PLANNING DIRECTOR'S SPECIAL PERMIT
1231 "I" STREET, SUITE 200, SACRAMENTO, CA 95814

- A. Negative Declaration
- B. Planning Director's Special Permit to allow a second 978 sq. ft. residential unit on an existing .23± acre deep lot in the Standard Single Family (R-1) zone.

LOCATION: 5886 28th Street

EXHIBIT - A SITE PLAN

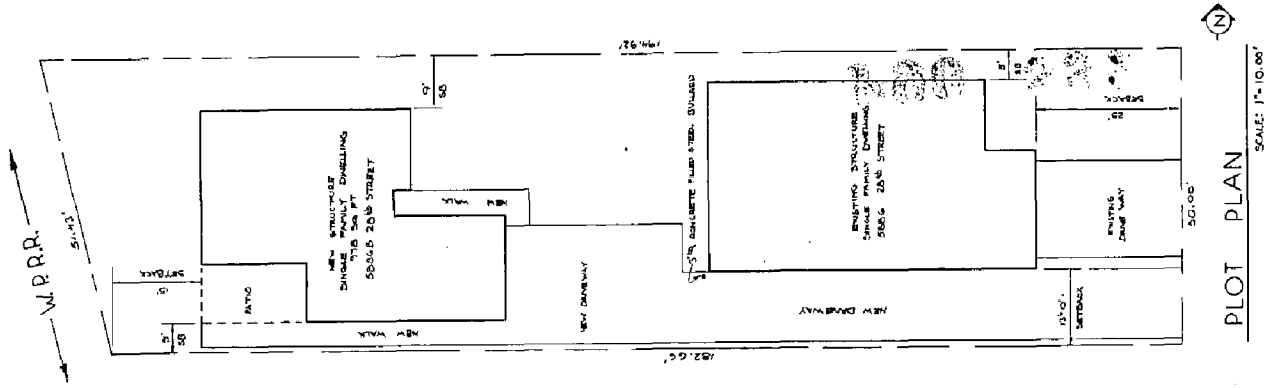
The plans as submitted indicate that more than the allowed 40% paving of the front yard setback area will occur if the proposed driveway is constructed. Staff has reviewed this problem with the applicant and the applicant has agreed to reduce the existing 20' x 25' driveway to a 10' x 25' driveway which will result in only 36% of the front yard area being paved. Staff recommends that the applicant submit a revised site plan reflecting the reduction of pavement in the front yard. As the proposed unit is compatible with the design of the existing unit and adequate yard area and parking are being provided for the unit, staff has no objections to the issuance of the special permit for the additional unit.

EXHIBIT - B ELEVATIONS

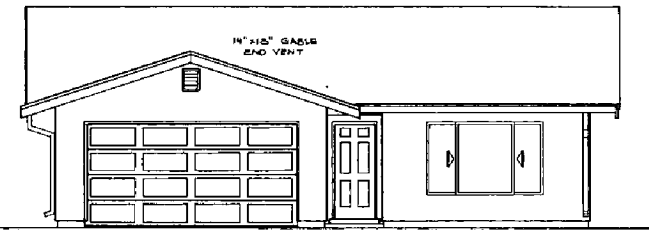
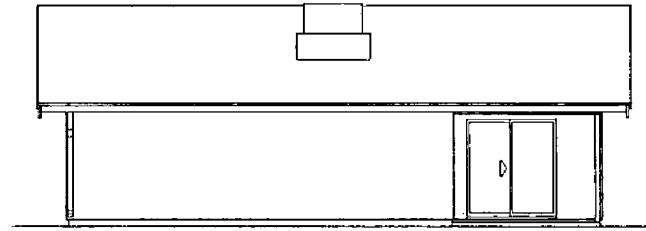
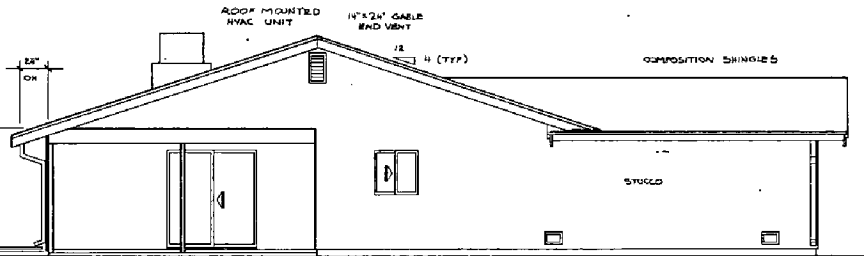
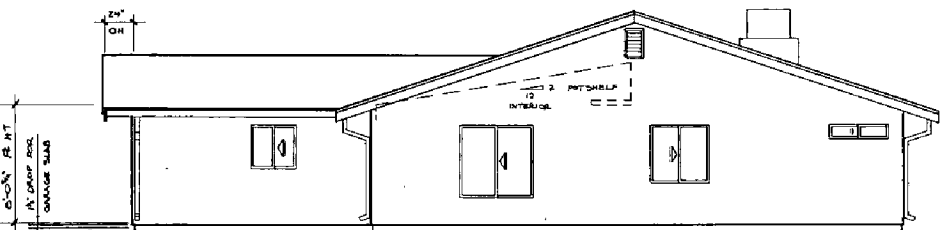
The design of the two bedroom, one bath and two car attached garage which is being proposed is similar in design to the existing single family residence on the subject site. The applicant is proposing a stucco exterior (terra cotta/tan) with wood trim and a composition shingle roof. The front door and the garage door on the existing single family residence are metal doors with panels. Staff recommends that the same type of doors be used on the proposed residence. The roof material to be utilized on the proposed unit is composition shingle. Staff recommends that a laminated dimensional shingle with a minimum 25 year rating be used.

1. The roof material shall be 25 year laminated dimensional shingles;
2. The design of the unit shall include the following:
 - a) The front door shall be panelled metal with a minimum of six panels;
 - b) The garage door shall be a metal sectional roll up door; and
3. The applicant shall obtain all necessary Building Permits.
4. The applicant shall submit a revised site plan indicating the reduction of pavement in the front yard are so as not to exceed the allowed 40% .
5. The applicant shall contact the City Planning Department for a site inspection upon completion of the proposed unit and prior to the final building inspection.
